# Release note

## Product : MD330U/MD330UI

| FW version   | 1.1.1037.0   |
| Release date | 2023/10/26   |

## 5. Support more options to overwrite the setting when Importing Setting Data

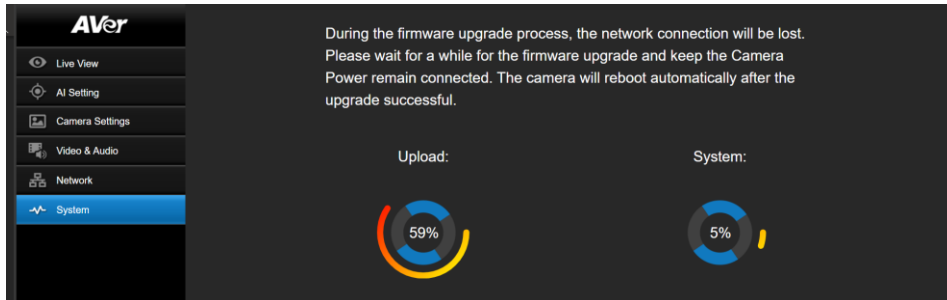
WebUI >> System >> Setting >> Import Setting Data

Check the [User Account] , [Network Setting] if you want to overwrite

## 1. Optimize the firmware update UI

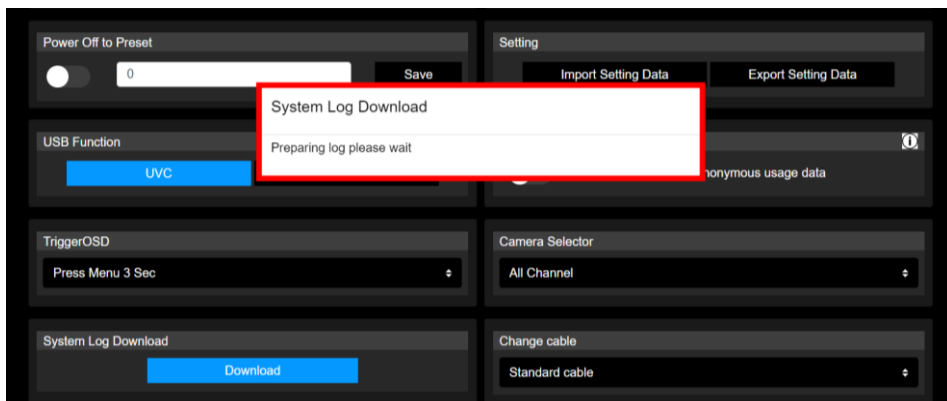
You can now clearly see the current progress of the update.

## 2. Optimize user flow when download log

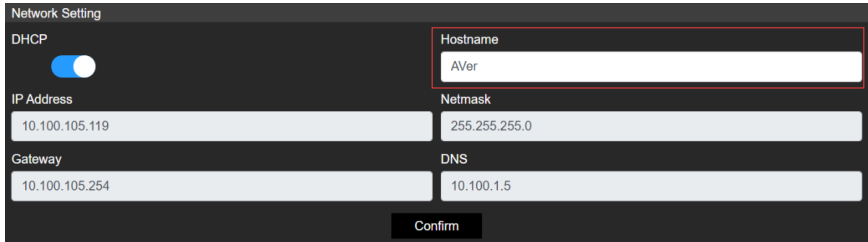
A prompt window will pop up when the UI is temporarily frozen due to downloading logs.
